Longs Ridge and Longs Creek Preliminary Overall Area Development Plan

RE: Long's Ridge and Long's Creek POADP
File #200.

Re: Long's Ridge and Long's Creek POADP
File # 85-18-63-88 (Revised November 27, 1985)

SUBJECT: Chronological History of POADP.

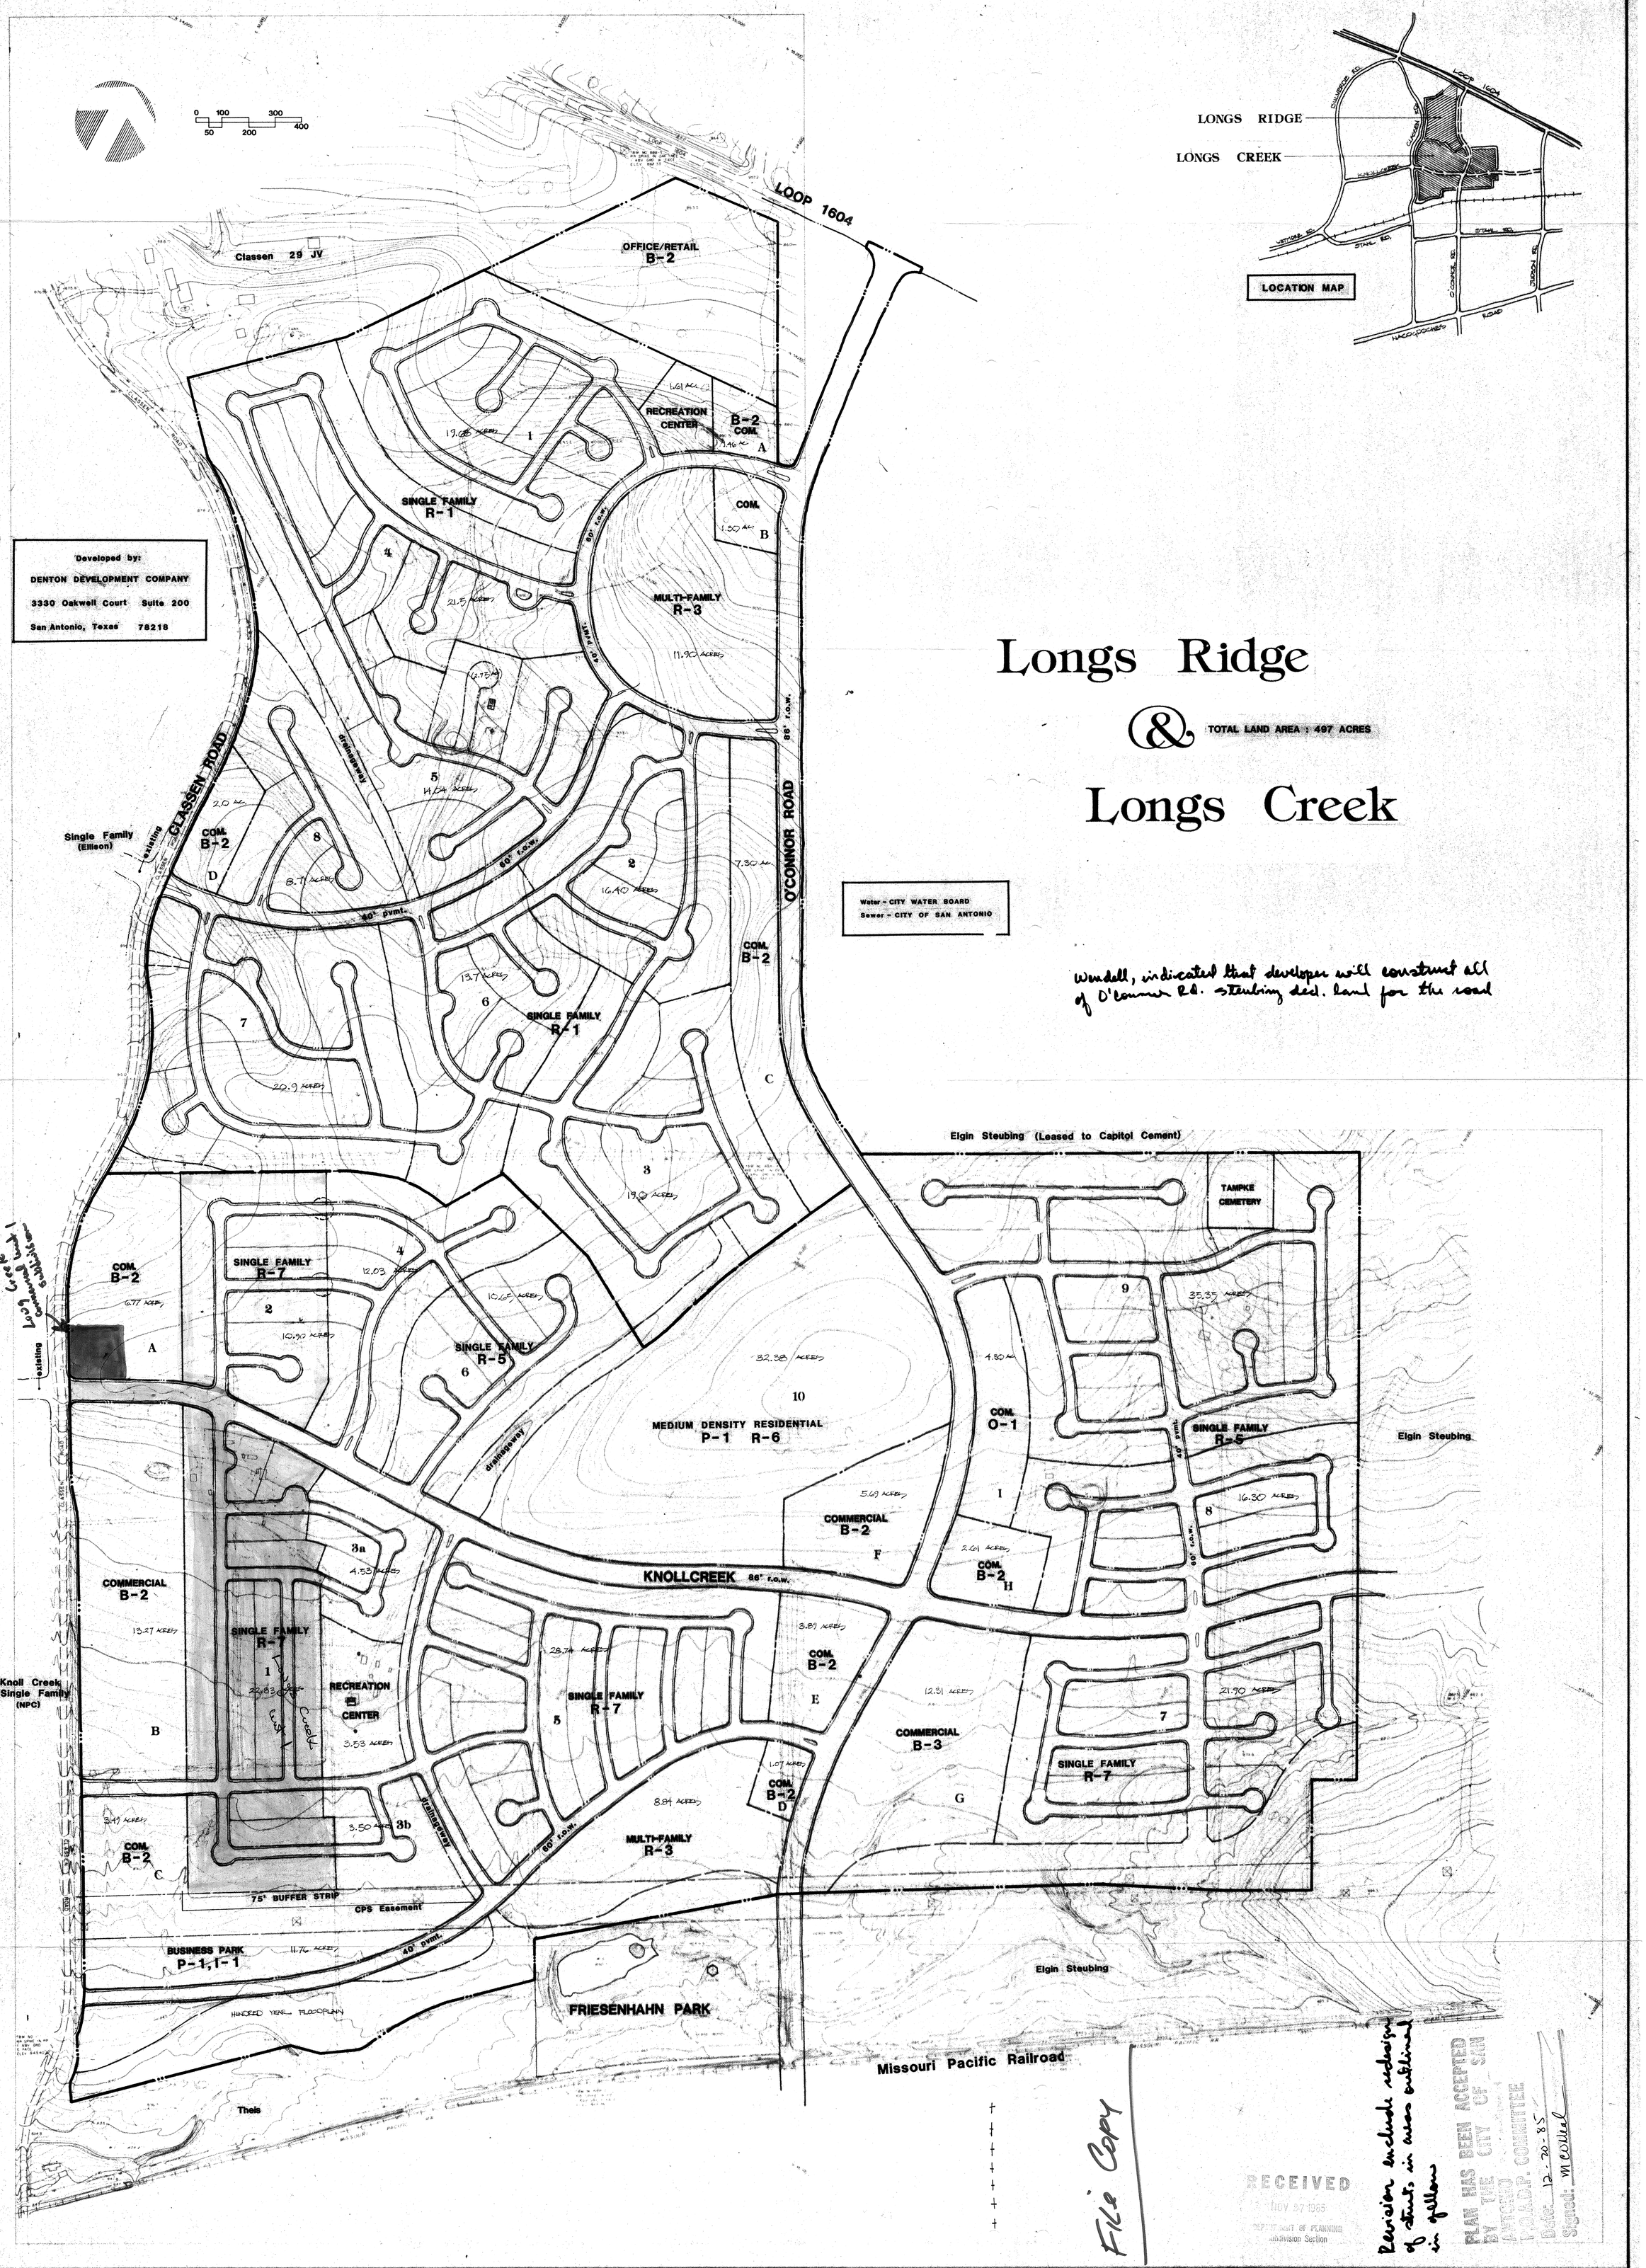
Wendell, indicated that developer will construct all of O'Connor Rd. stemming ded. land for the road

Revision includes redesign of streets in areas outlined in yellow

The POADP Committee has reviewed and accepted the revised plan for Long's Ridge and Long's Creek. However, the Committee requests that you reconsider the alignment of the 60' street between Classen and O'Connor Roads as indicated on the attached plan. The Committee believes this street will and should function as a collector and that the revised alignment will create a potential safety hazard.

PRELIMINARY OVERALL AREA DEVELOPMENT PLAN

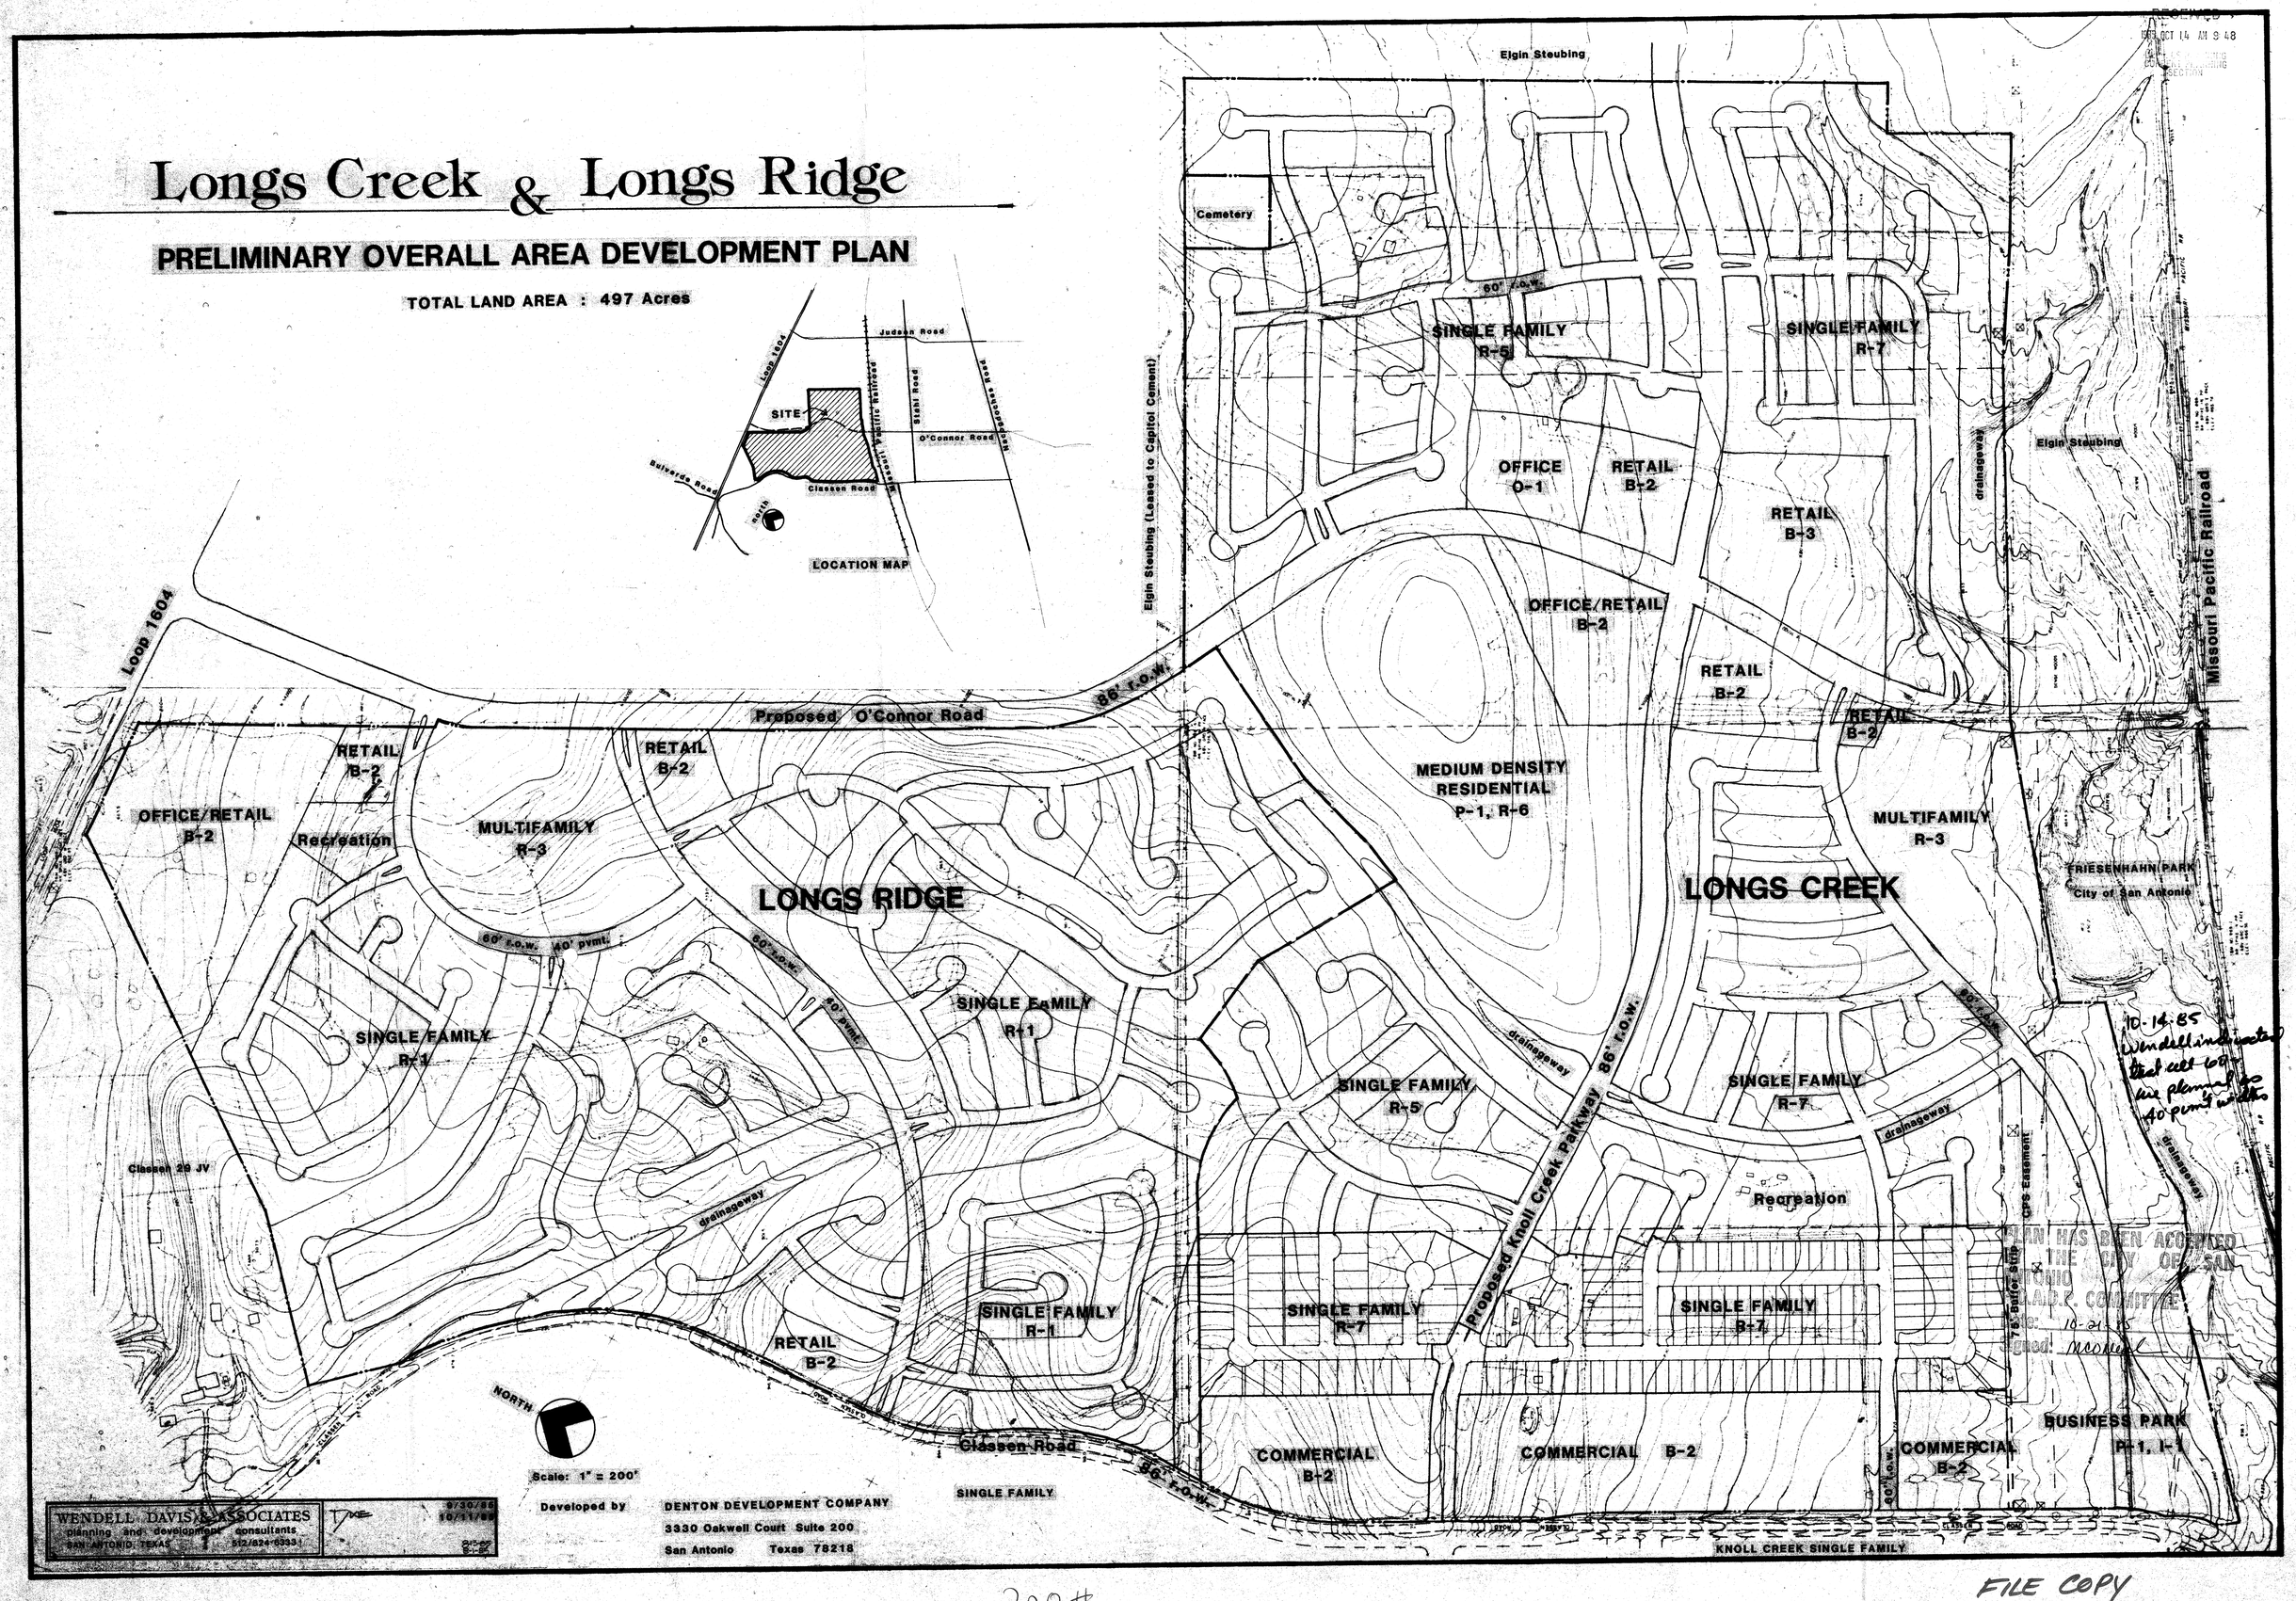
10-14-85
Wendell indicated that will be in plan to 40 pvmt widths
